# Access Compliance Report

## Public Rights-of-Way

Intersection ID: 24081	Main Street: PRESCOTT_POND_LN	Cross Street: SHARPTHORNE_PL	Location: SW
ADA ID: 05A0291D1303	Ramp Type: PerpDiag	Initial Pass/Fail: Fail	Overall Compliance: No
Severity Score: 22.5			
Codes/Mitigation Info/Possible Solution		Field Measurements/Component Compliance

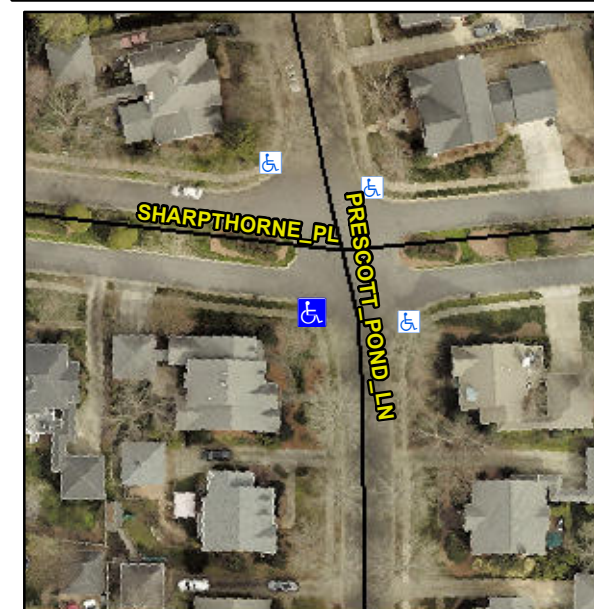
**Not Found, R304.5.1, R304.2.2, R304.5.3**

Compliance	Description	Data	Compliance	Description	Data
N/A	Ramp Length (in)	47.5	No	Ramp Slope (%)	9.0
No	Ramp Width (in)	46.0	No	Ramp XSlope (%)	4.7
N/A	Flare Type LT	N/A	N/A	Flare Type RT	N/A
N/A	Flare Slope LT (%)	N/A	N/A	Flare Slope RT (%)	N/A
N/A	Flare Traversable LT?	N/A	N/A	Flare Traversable RT?	N/A
N/A	Landing Length (in)	N/A	N/A	DWS Provided?	N/A
N/A	Landing Width (in)	N/A	N/A	DWS Contrast?	N/A
N/A	Landing Slope (%)	N/A	N/A	DWS Length (in)	N/A
N/A	Landing X Slope (%)	N/A	N/A	DWS Full Width?	N/A
N/A	Landing Curb? (Y/N)	N/A	N/A	DWS Offset (in)	N/A
N/A	Shared Landing?	N/A			
N/A	Gutter Ponding?	N/A	N/A	Gutter Slope (%)	N/A
N/A	Gutter Lip Ht (in)	N/A	N/A	Gutter X Slope (%)	N/A
N/A	Painted X Walk1?	No	N/A	Painted X Walk2?	No
	X Walk 1 Direction	To E		X Walk 2 Direction	To N
N/A	X Walk 1 Width (in)	N/A	N/A	X Walk 2 Width (in)	N/A
	X Walk 1 Slope (%)	8.1		X Walk 2 Slope (%)	0.5
	X Walk 1 X Slope (%)	2.3		X Walk 2 X Slope (%)	7.0

**Remove & Replace Curb Ramp With Two New Directional Ramps or Equivalent.**
